Site Instruction

SI 36

PROJECT : Hampton Manor
PROJECT No : 1136.13
DATE : June 11, 2019

Title: Revised South Exit Stair

04.	JUNE.11.2019	SUITE REVISION SOUTH EXIT STAIR	B.G.
05.	NOV.23.2017	SUITE TERRACE/PATIO & STEP REVISION	B.G.
02.	SEP.10.2017	SUITE TRANSOM/BALCONIES REVISION	B.G.
01.	AUG.21.2017	SUITE SANDBLAST PRECAST ON BALCONIES	B.G.

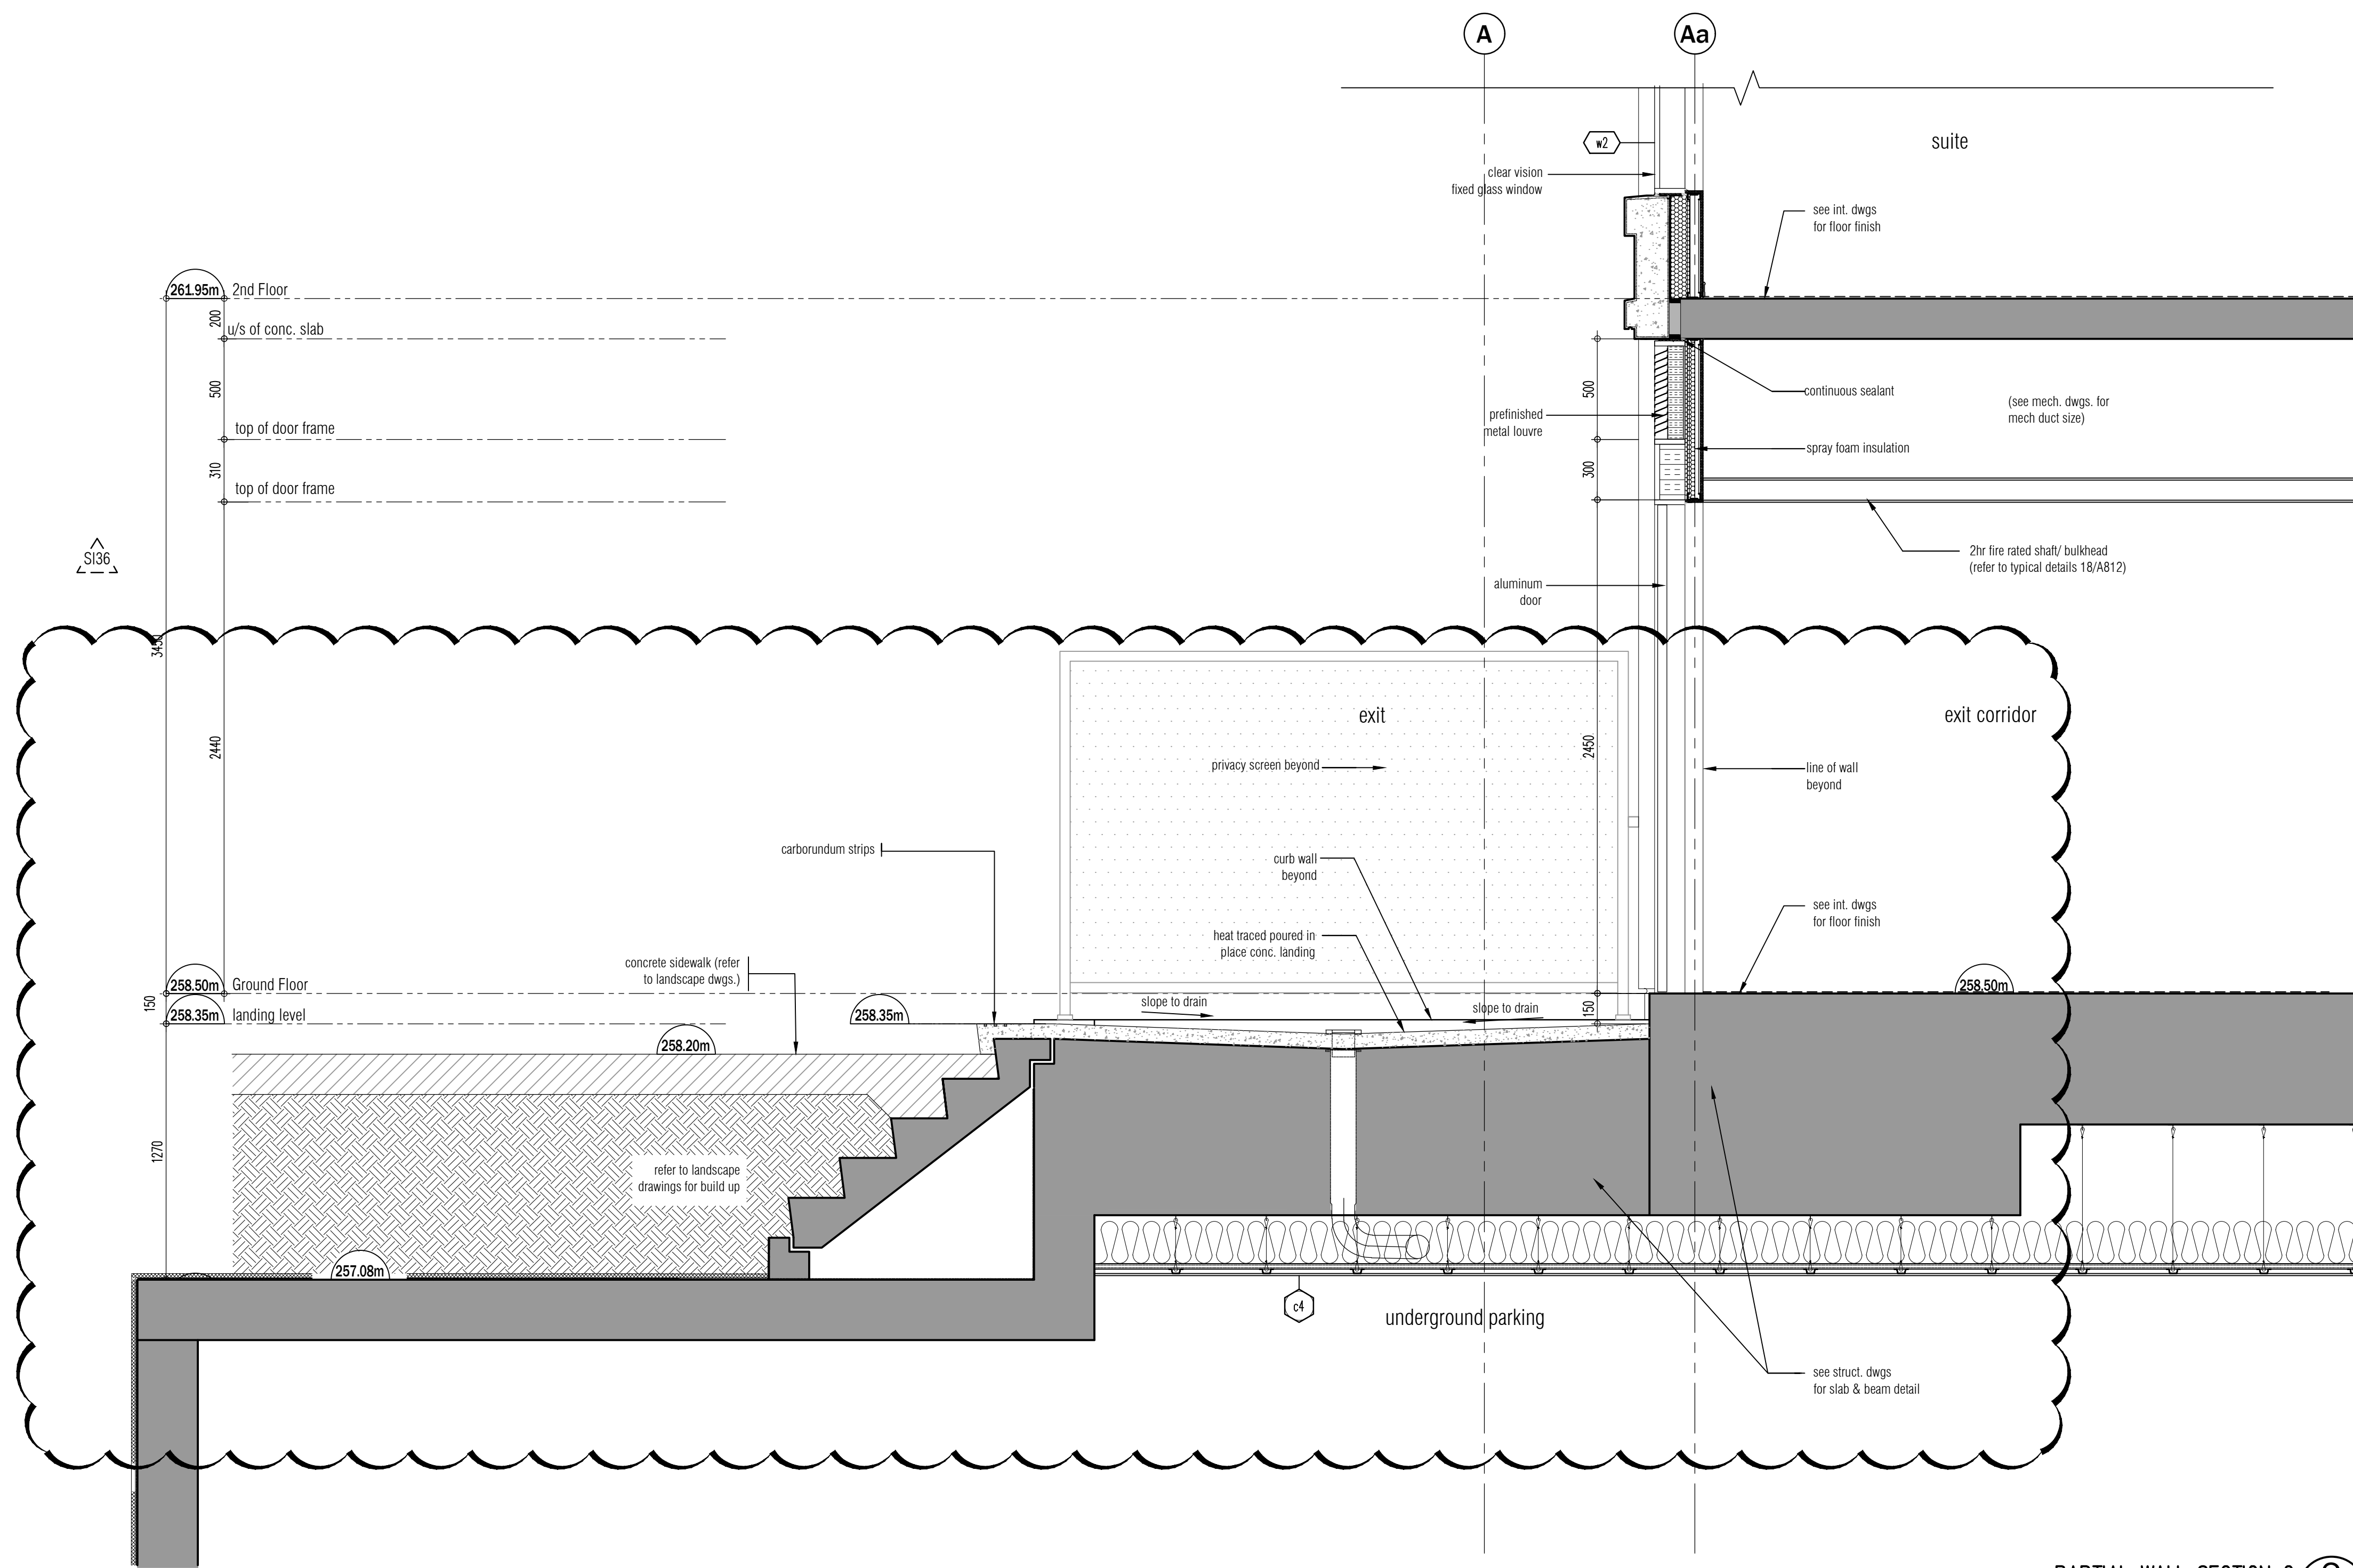
A606 – Partial Wall Section

- Revision to South exit stair to match grading.
